# EXHIBIT A

## STAFF REPORT COMMUNITY DEVELOPMENT DEPARTMENT

HEARING DATE: 8/11/2020  
TO: Mayor & City Council  
FROM: Sonya Allen, Associate Planner  
208-884-5533  
SUBJECT: H-2020-0066 Apex – MDA, AZ, RZ  
H-2020-0056 Apex Northwest – PP  
H-2020-0057 Apex Southeast – PP  
(to be marketed as “Pinnacle”)

**A. Master Plan (Revised)**

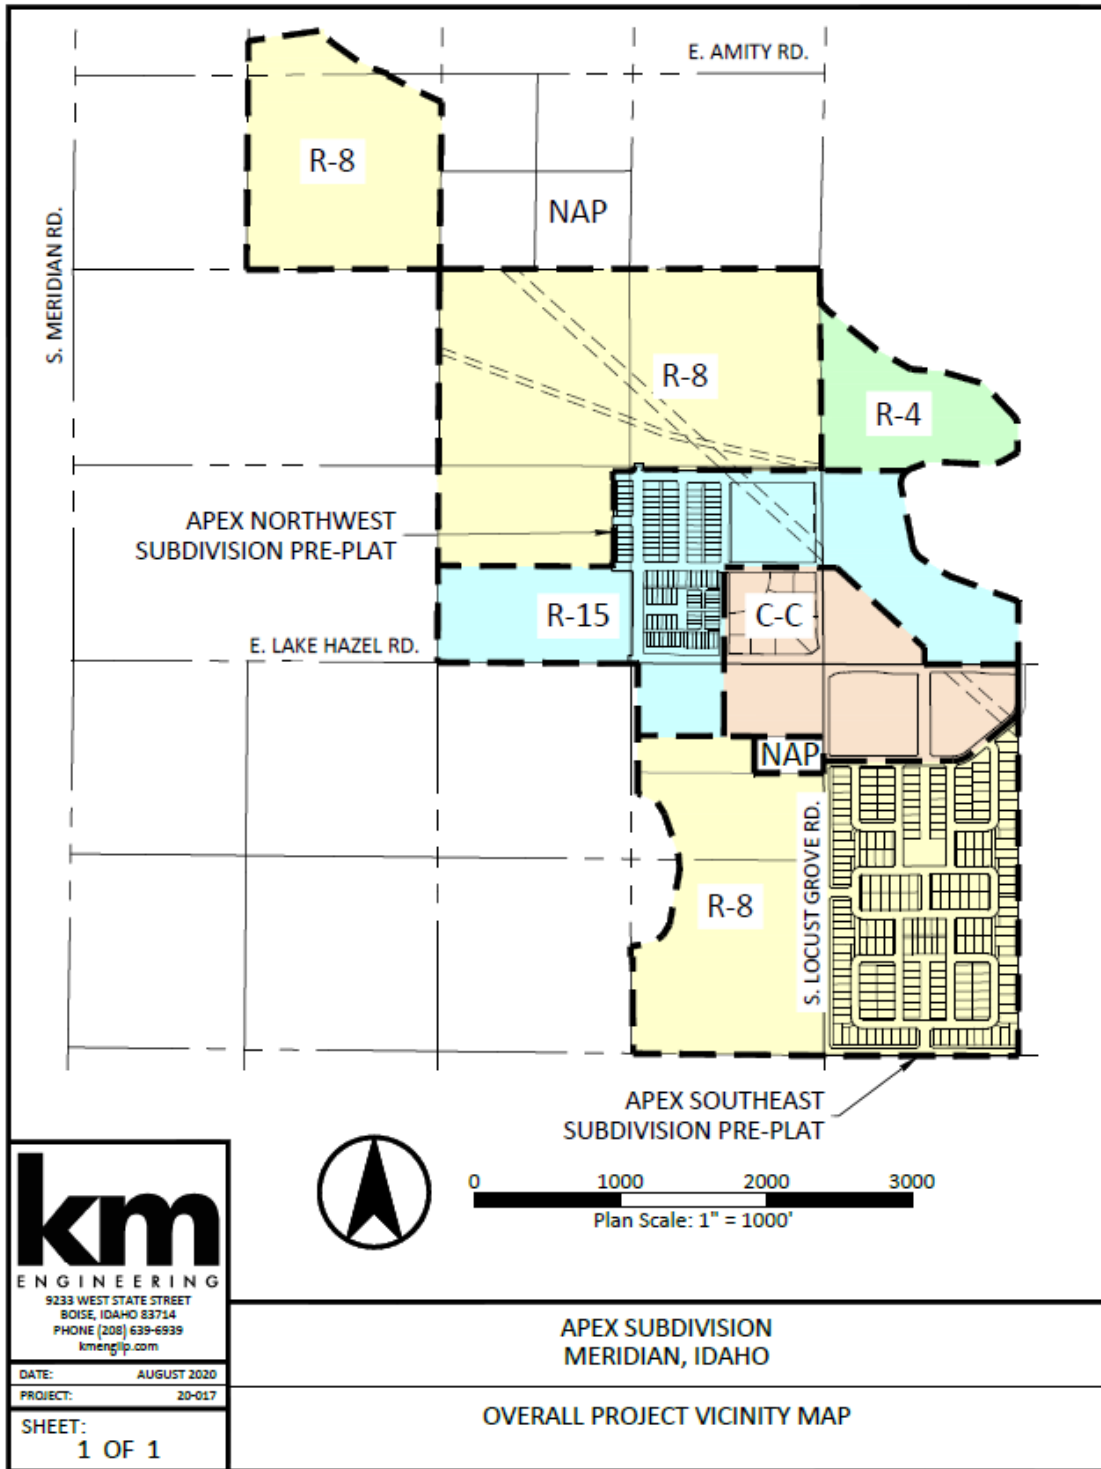
Staff recommends the proposed Master Plan is included in the new DA along with the provisions for future development listed in Section IX.A.1 to ensure compliance with the MU-C FLUM designation.

- d. Prior to development of the Mixed Use – Community (MU-C) designated areas shown on the Master Plan as “future development,” the Development Agreement shall be amended to include a conceptual development plan that demonstrates consistency with the general guidelines for Mixed Use developments and specifically the MU-C designation (see pgs. 3-13 and 3-15 thru 3-16).

# E. Landscape Plan (date: 4/30/2020)

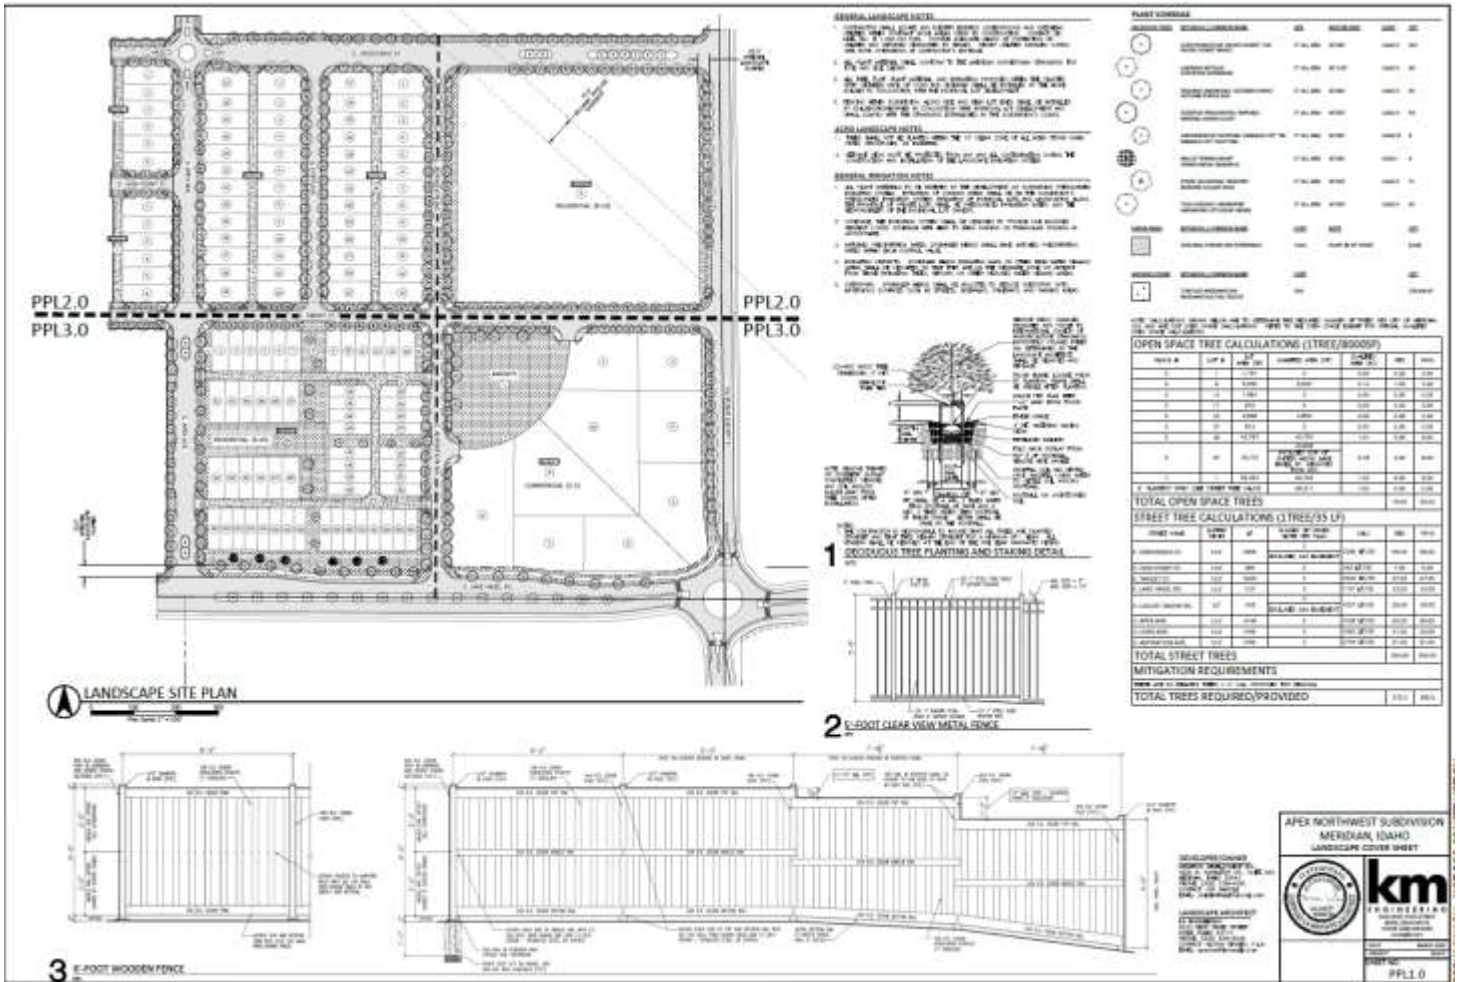
4. The landscape plan submitted with the final plat application for Apex Northwest shall be revised as follows:
    - a. Depict multi-use pathways in accord with the Pathways Master Plan as required by the Park's Dept. in Section IX.E. Landscaping shall be depicted along either side of the pathways as set forth in UDC 11-3B-12C.

- f. Depict a gazebo with tables and benches as an amenity in Lot 32, Block 5; include a detail of the gazebo.
5. The landscape plan submitted with the final plat application for Apex Southeast shall be revised as follows:

Southeast:

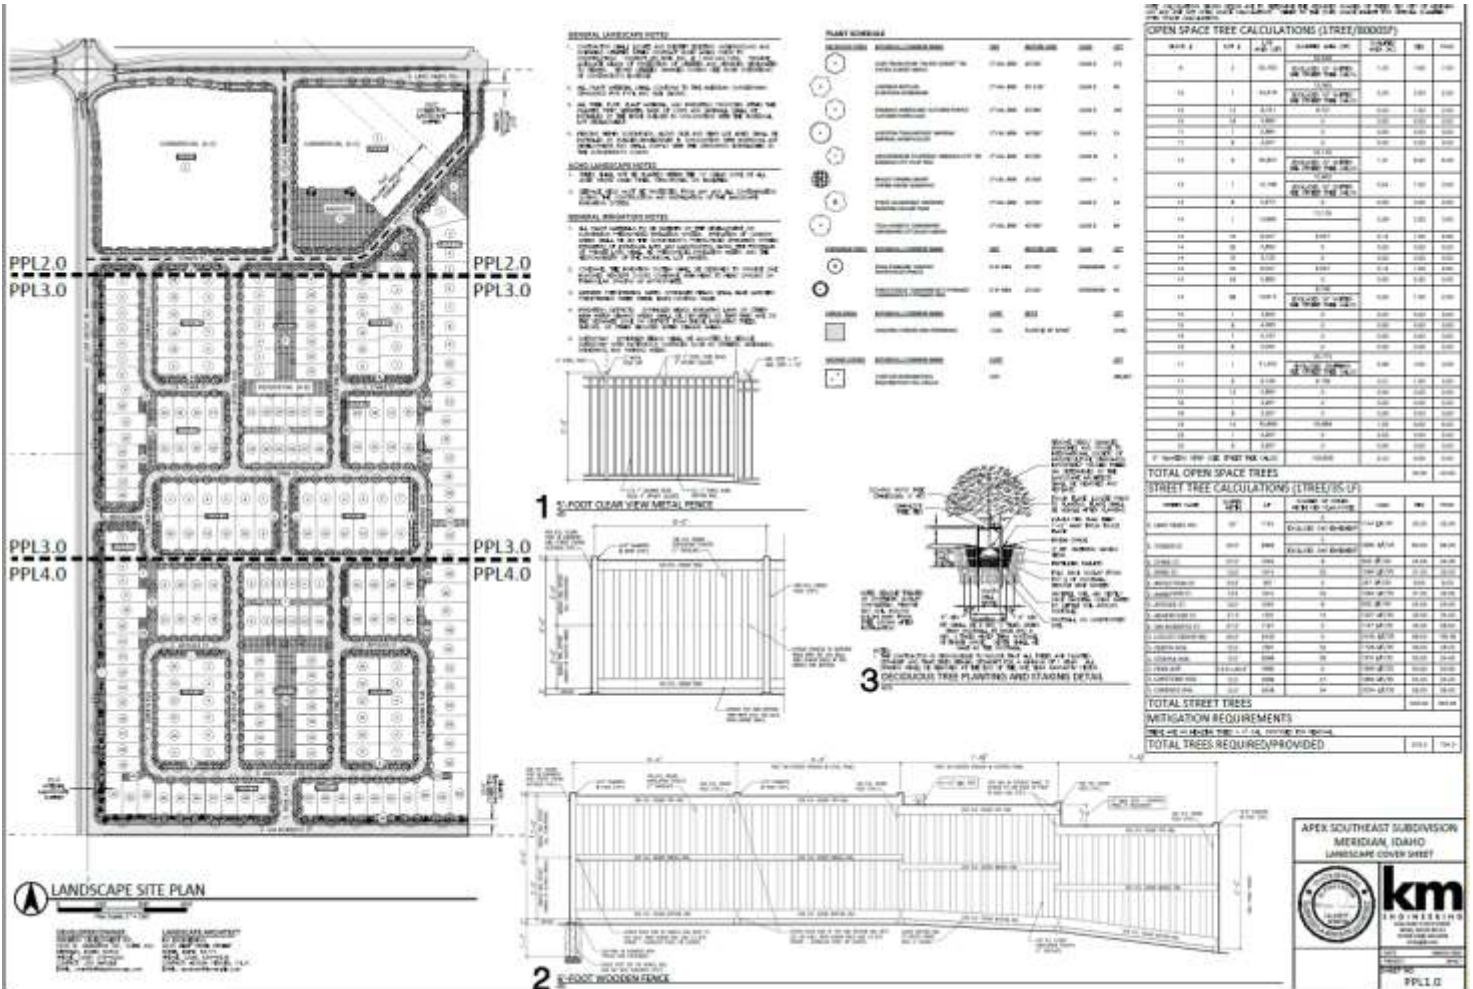
- a. Depict multi-use pathways in accord with the Pathways Master Plan as required by the Park's Dept. in Section IX.E. Landscaping shall be depicted along either side of the pathways as set forth in UDC 11-3B-12C.

- g. Depict the children's play equipment proposed in the central common area; include a detail of the play equipment.
  6. Future development shall be consistent with the minimum dimensional standards listed in UDC Tables 11-2A-6, 11-2A-7 and 11-2B-3 for the R-8, R-15 and C-C zoning districts respectively.

# F. Qualified Open Space Exhibit (dated: ~~March~~ May 2020) - REVISED

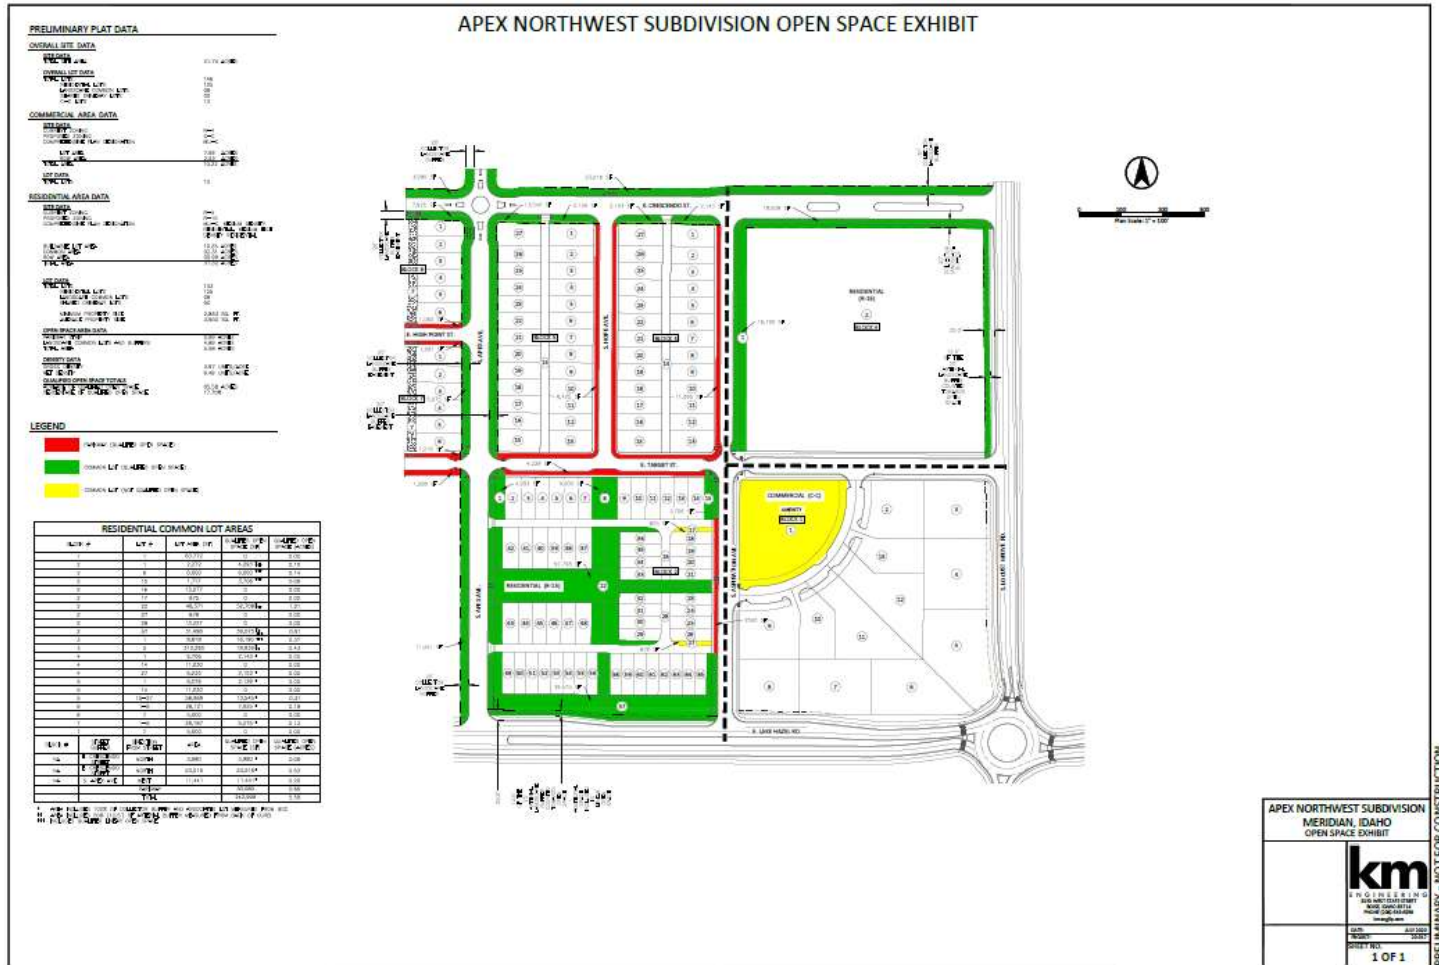
- 4. Commission change(s) to Staff recommendation:
  - a. If revised qualified open space exhibit depicts qualified area less than 10% that the amphitheater in the commercial area be allowed to count toward the requirement through an alternative compliance request to UDC 11-3A-3.

- ~~13. The qualified open space exhibits for the residentially zoned portions of Apex Northwest and Apex Southeast shall be revised prior to the Council hearing to only depict areas that qualify per the standards listed in UDC 11-3G-3B. If additional qualified open space is needed, the plat should be revised to comply.~~
